SUPPLEMENTARY REPORT

HUNTER AND CENTRAL COAST REGIONAL PLANNING PANEL

PANEL REFERENCE & DA NUMBER	PPSHCC-296 MA2022/00433
LGA	City of Newcastle (CN)
PROPOSED DEVELOPMENT	Section 4.55(2) modification to amend condition no. 76 of DA2019/01150 to allow the use of the outdoor terrace (associated with the Rooftop Bar) between 10:00pm and 12:00 midnight, Monday to Saturday.
STREET ADDRESS	185 Hunter Street, Newcastle
APPLICANT	URBIS PTY LTD
OWNER	EAST END STAGE 1 PTY LTD
DATE OF MODIFICATION LODGEMENT	1 December 2022
DATE OF DETERMINATION MEETING	19 August 2024
APPLICATION TYPE	Modification Application under Section 4.55(2)
REGIONALLY SIGNIFICANT CRITERIA	<p>Section 275 of the <i>Environmental Planning and Assessment Regulation 2021</i> states that a council must not determine an application to modify a development consent under the Act, Section 4.55(2), on behalf of a regional planning panel, if the application is of a kind specified in the <i>Instruction on Functions Exercisable by Council on Behalf of Sydney District or Regional Planning Panels— Applications to Modify Development Consents</i> published on the NSW Planning Portal on 30 June 2020.</p> <p>Council is not able to determi

Figure 1: Site and surrounds

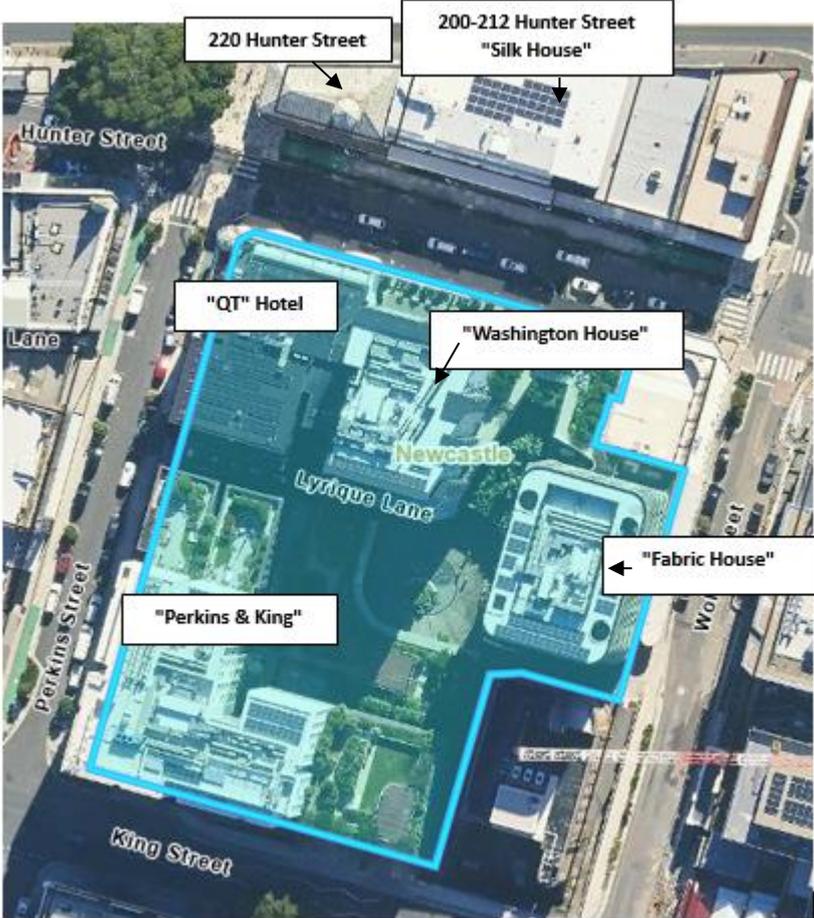
The description contained under *Section 1.2 - The Locality* is amended to include reference to the following surrounding properties and buildings:

Buildings located opposite the subject site, along on the northern side of Hunter Street Mall include:

- A 6-storey building comprising ground floor retail and 5 levels of residential apartments above. The site is identified as 200-212 Hunter Street and is commonly known as "Silk House"; and
- A 4-storey building comprising ground floor retail / commercial and 3 levels of residential apartments above. The site is identified as 220 Hunter Street and is commonly known as the "Former Commonwealth Bank".

Buildings to the east of the subject site include:

- A 10-storey residential apartment building located adjacent to the site. This building is commonly known as "Washington House"
- A 11-storey building with ground floor retail and 10 levels of residential apartments above. This building is commonly known as "Fabric House".

South of the site:

- A 11-storey building with ground floor retail and 10 levels of residential apartments above. This building is referred to as "Perkins & King".

It is confirmed the above properties have been considered in the assessment of the application, particularly in relation to noise impacts and residential amenity.
